SUBJECT: BOARD NOTIFICATION - SUMMARY OF MEETING BETWEEN  
NRC STAFF AND TEXAS UTILITIES GENERATING COMPANY  
CONCERNING THE DESIGN OF PIPING AND PIPE SUPPORTS  
AT COMANCHE PEAK (BOARD NOTIFICATION NO. 85- 026)

APPLICANT: Texas Utilities Generating Company (TUGCO)  
FACILITY: Comanche Peak Steam Electric Station, Units 1 and 2  
SUBJECT: SUMMARY OF MEETING BETWEEN NRC STAFF AND TEXAS  
UTILITIES GENERATING COMPANY CONCERNING THE  
DESIGN OF PIPING AND PIPE SUPPORTS AT COMANCHE  
PEAK STEAM ELECTRIC STATION, UNITS 1 AND 2

Distributed at this meeting was a draft report prepared by Mr. Donald F. Landers, an NRC staff consultant. The draft report identifies many of the unresolved matters in the staff review as they relate to the design of piping and pipe supports at Comanche Peak. A copy of the draft report was bound into the transcript.

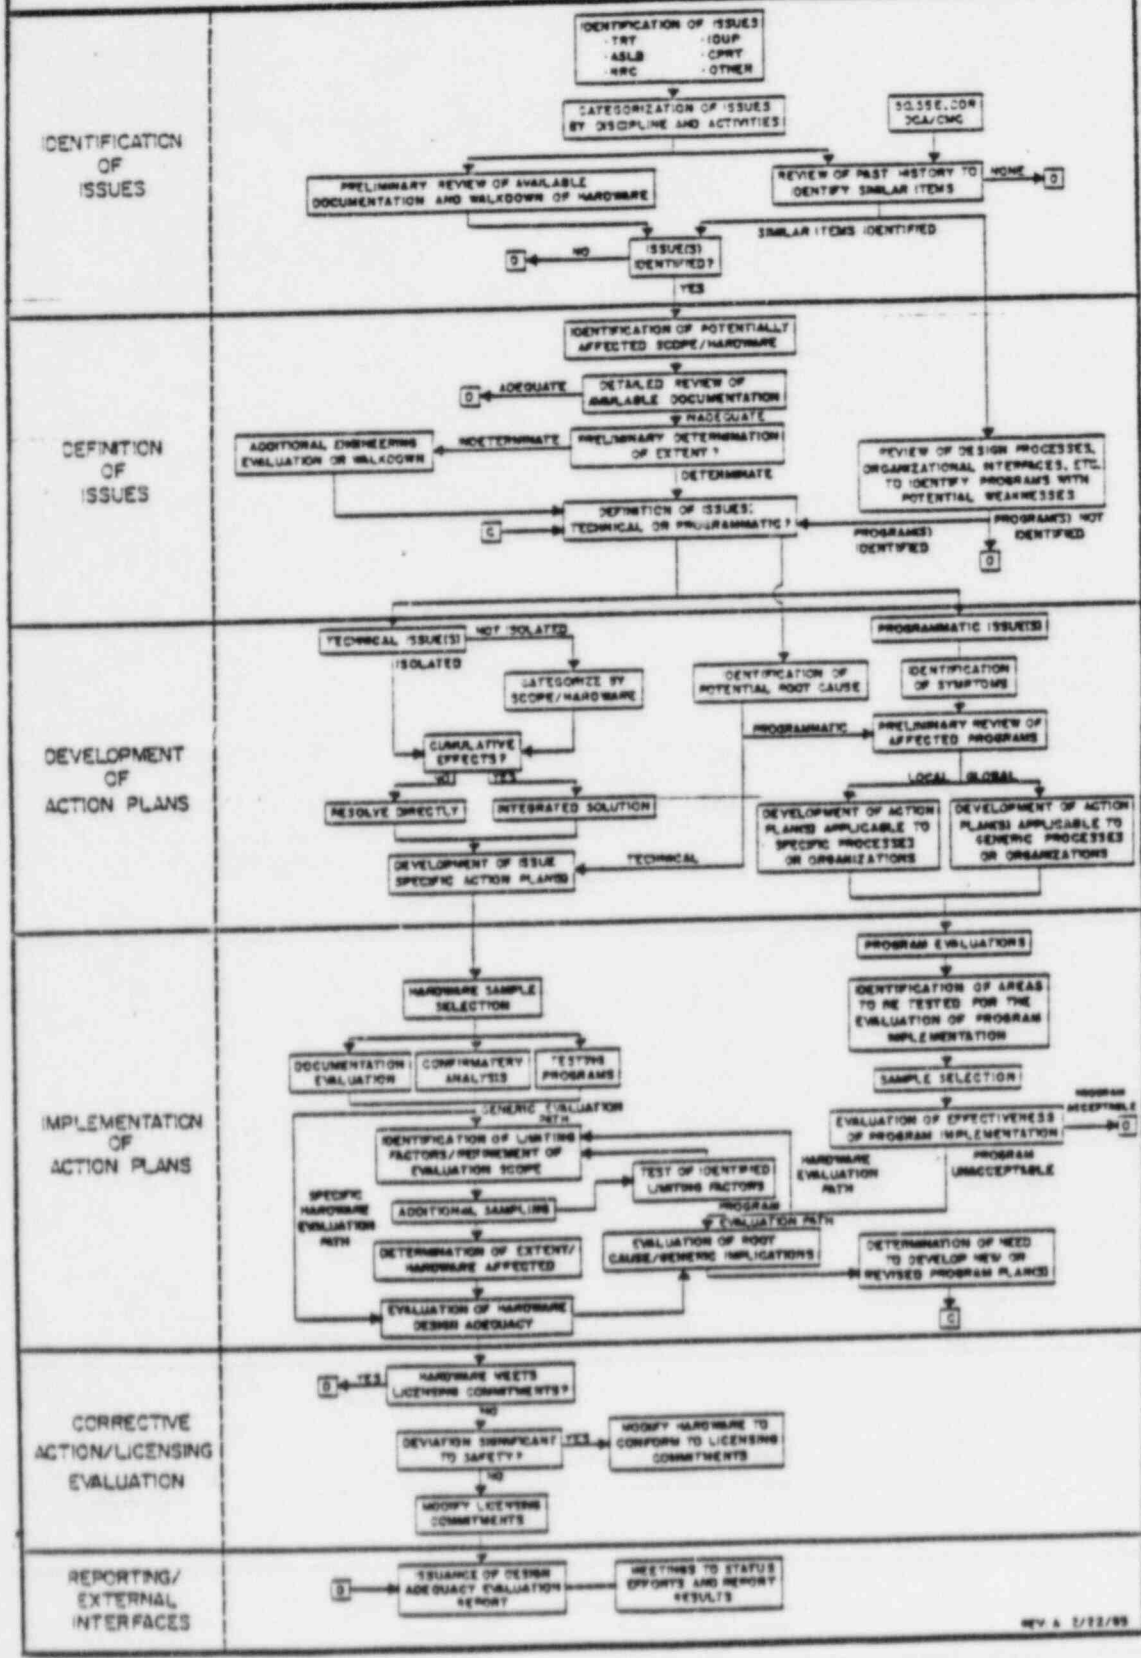
6 The "Implementation of Action Plans" box,  
7 it's the third one down, we believe should include  
8 provision for a Staff audit of specific hardware  
9 evaluation bases. What are your bases for deciding  
10 whether or not a particular component support is good  
11 or bad?

14 The next one in the "Implementation of  
15 Action Plans," that block again, it's the next one  
16 down, that, as Vince has mentioned here, should  
17 include provisions for modifying inadequate. If you  
18 find inadequate Unit 1 programmatic procedures, make  
19 them adequate for Unit 2, if you are still doing work  
20 under those procedures.

9           And lastly, in the "Corrective Action"  
10 block, we need to have a provision for Staff audit of  
11 the hardware being modified to be sure that in fact  
12 the modification makes that piece of hardware conform  
13 to the licensing commitments.
